PCN Number: 1604-3
Chgnot.doc rev. __ 4/16

Product/Process Change Notification (PCN)

Customer: SOLID STATE SUPPLIES LTD

1. Package:

Legacy UA

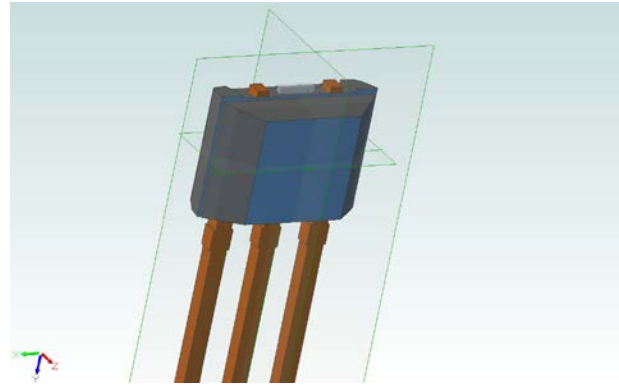
Legacy UA vs Matrix HD UA - Visual Differences

Matrix HD UA

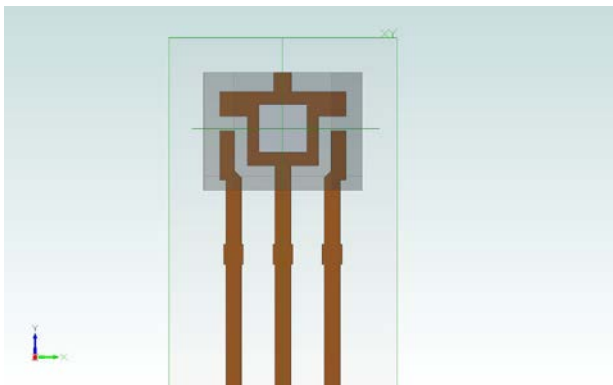
- Top of package on the Matrix HD UA has tie and dam bar protrusions

Legacy UA vs Matrix HD UA – Dimensional Comparison

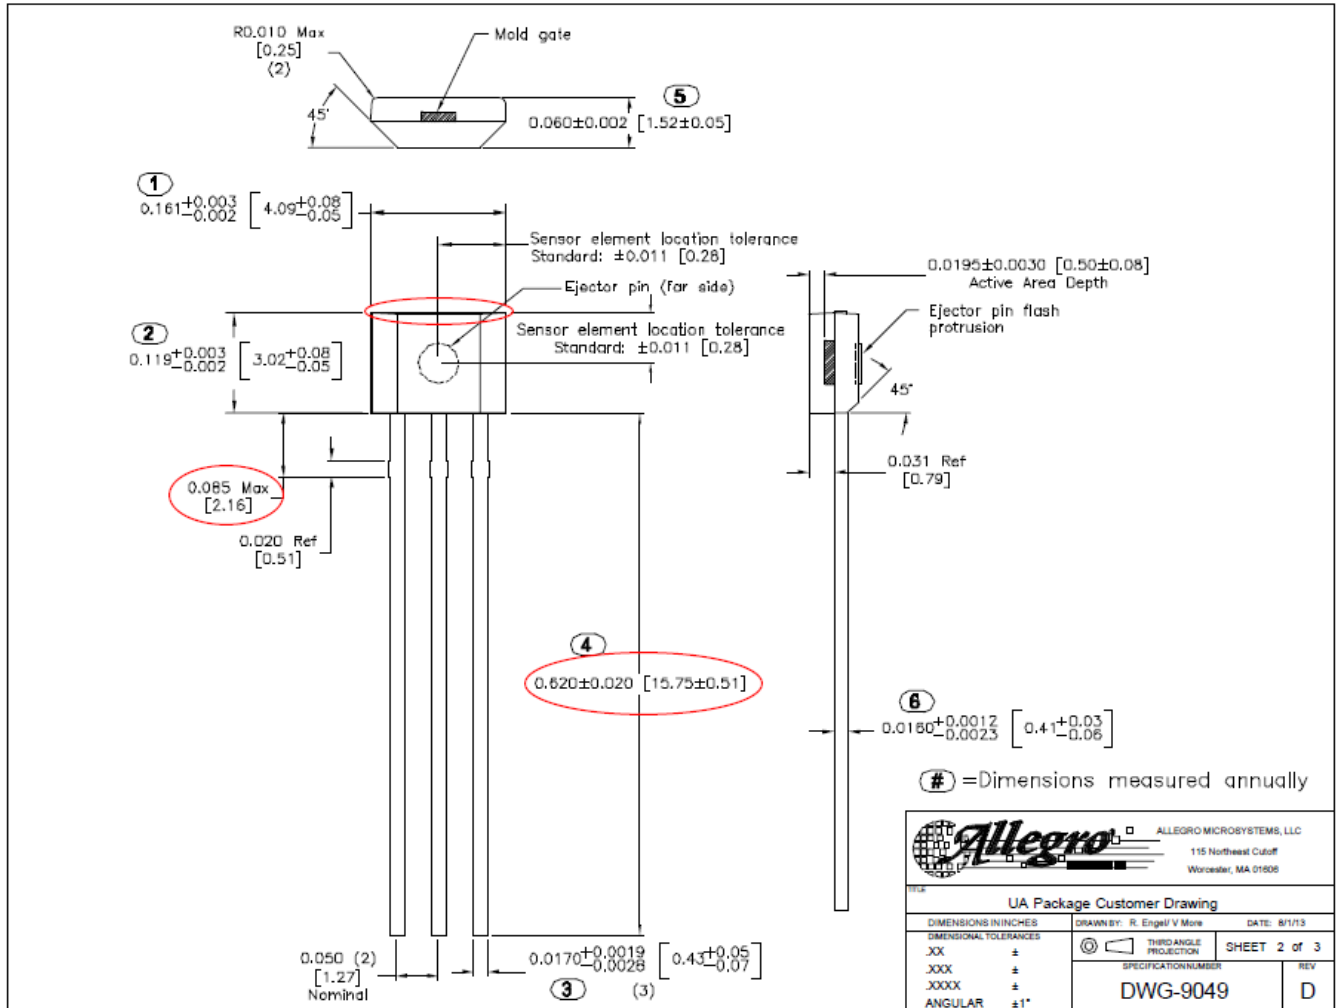
Package lead length: 15.75 +/- 0.51 mm

Dam bar from package: 2.16 mm

Legacy UA vs Matrix HD UA – Dimensional Comparison Continued

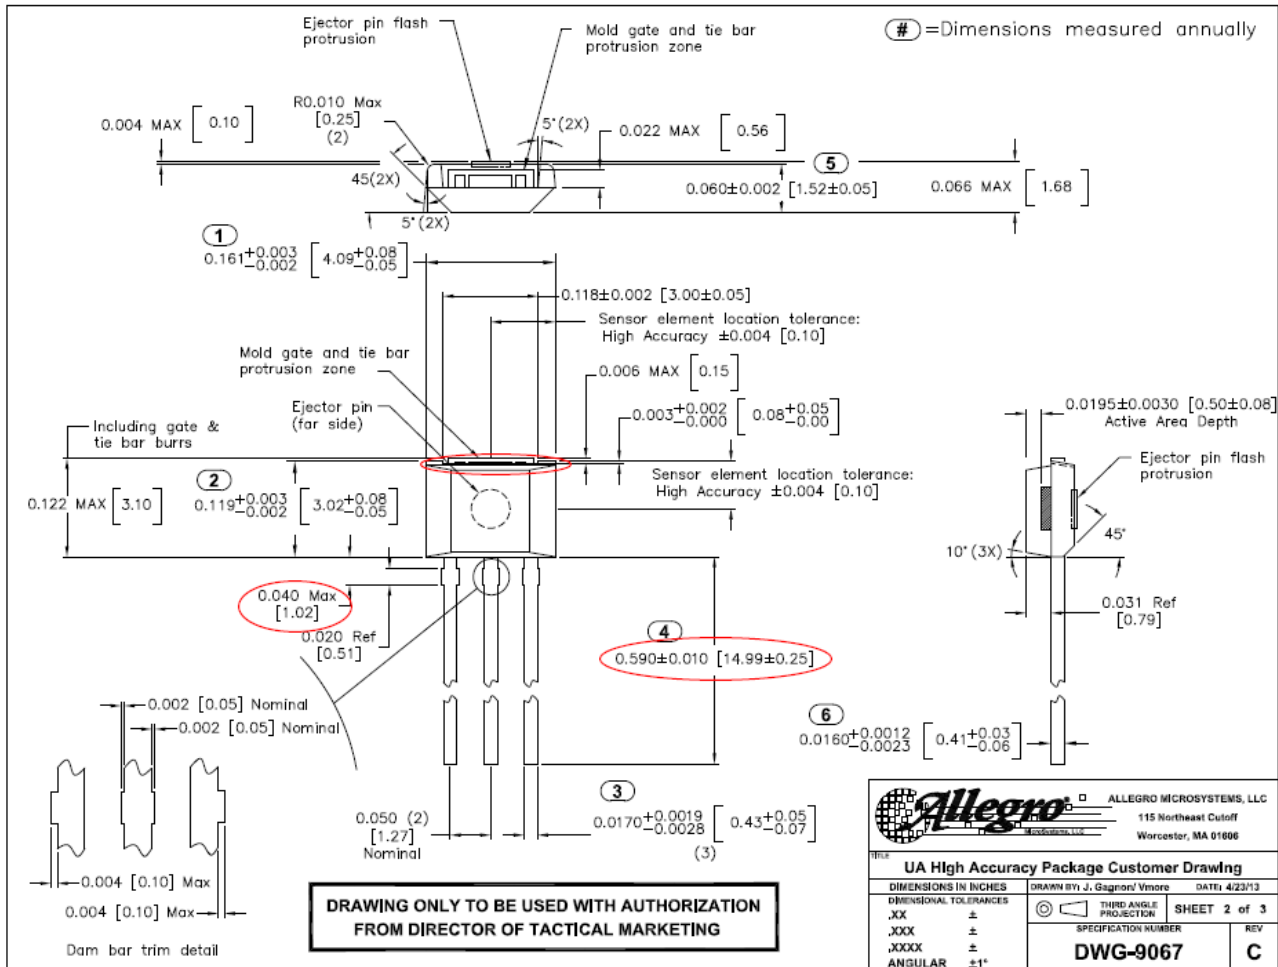
Package	Width (mm)	Height (including tie & gate bar protrusions) (mm)	Lead Length (mm)	Leadframe Mold Offset (mm)
Legacy UA	4.09 (+0.08, -0.05)	3.02 (+0.08, -0.05)	15.75 +/-0.51	+/-0.101
Matrix HD UA	4.09 (+0.08, -0.05)	3.02 (+0.08, -0.05)	14.99 +/-0.25	+/-0.051

Package lead length: 14.99 +/- 0.25 mm

Dam bar from package: 1.02 mm
